## **Virginia Commonwealth University**

### **VCU Standard Streetscape Encroachment Package - Revised**

#### **Application for Urban Design Committee**

Submission Date: April 13, 2023

Typical Brick Paver at Sidewalk Paving with Street Tree Planter

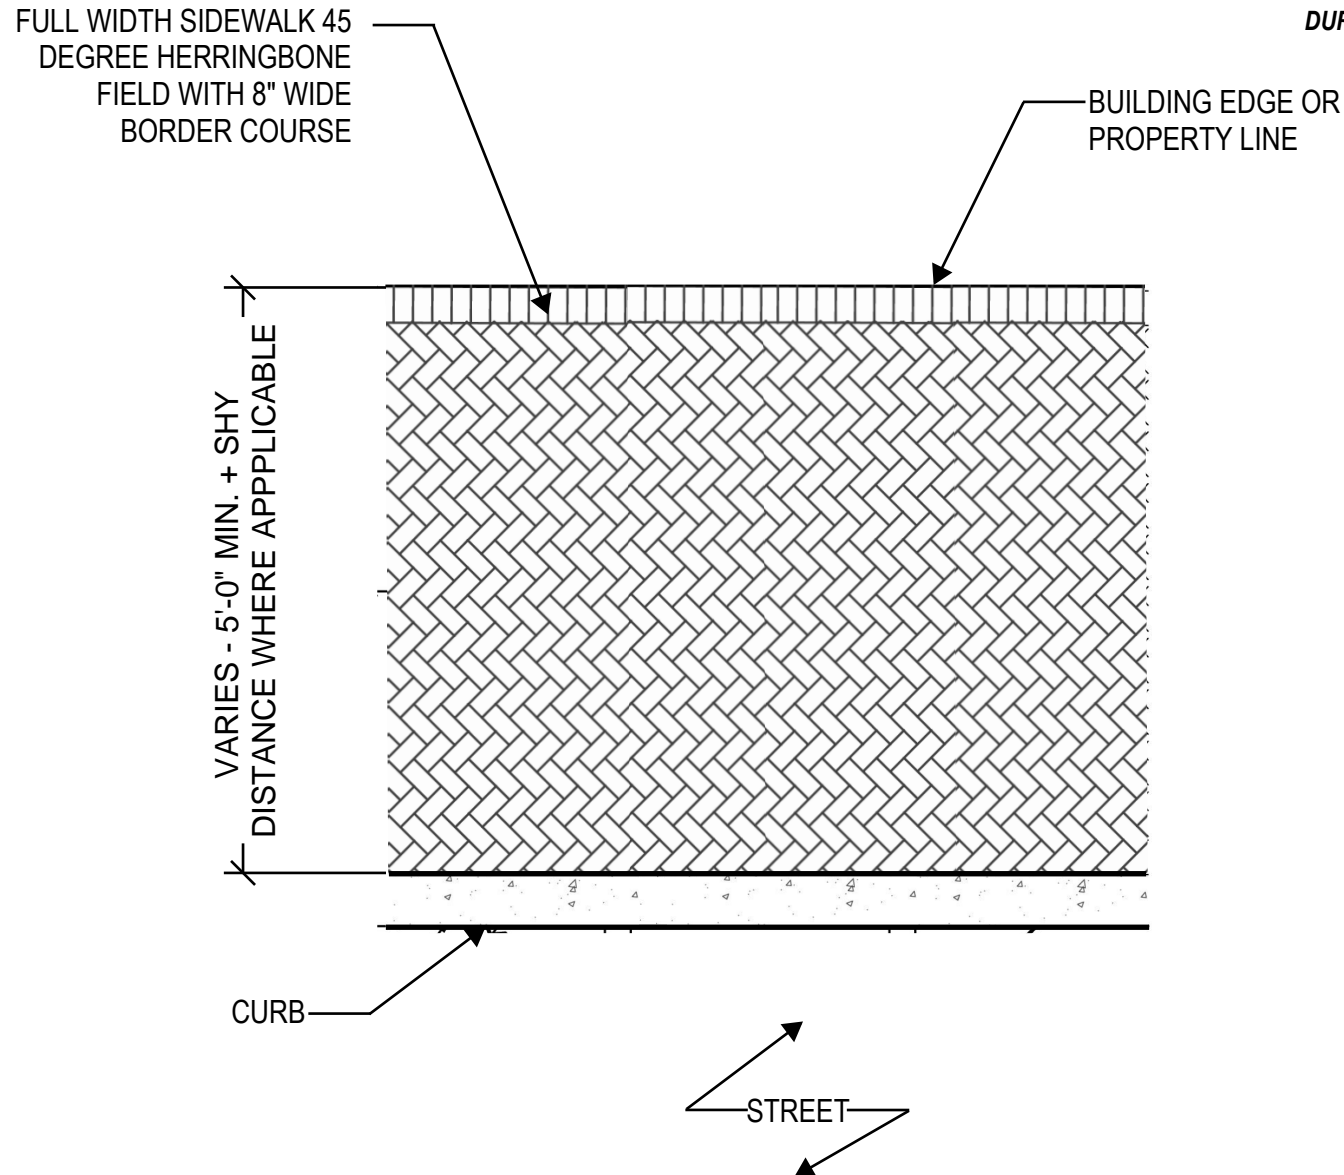
- **2023 Revisions:** The revisions being proposed to the 2016 standards pertain to modifying the standard tree well design to better align to the increased tree well size that the City of Richmond has implemented on West Broad Street as well as implementing a raised border curb around the tree well that has been approved on recent projects on VCU's Monroe Park Campus. The increased tree well size improves the health of street trees and deters pedestrians from crossing the street mid block. The raised curb helps keep sidewalk salt out of the tree wells.

WHEN A RAISED CONCRETE BORDER CURB OCCURS ADJACENT TO STREET PARKING, THE PLANTER SHALL BE MOVED +/- 24" AWAY FROM THE STREET CURB TO PROVIDE CAR DOOR OPERATING CLEARANCE
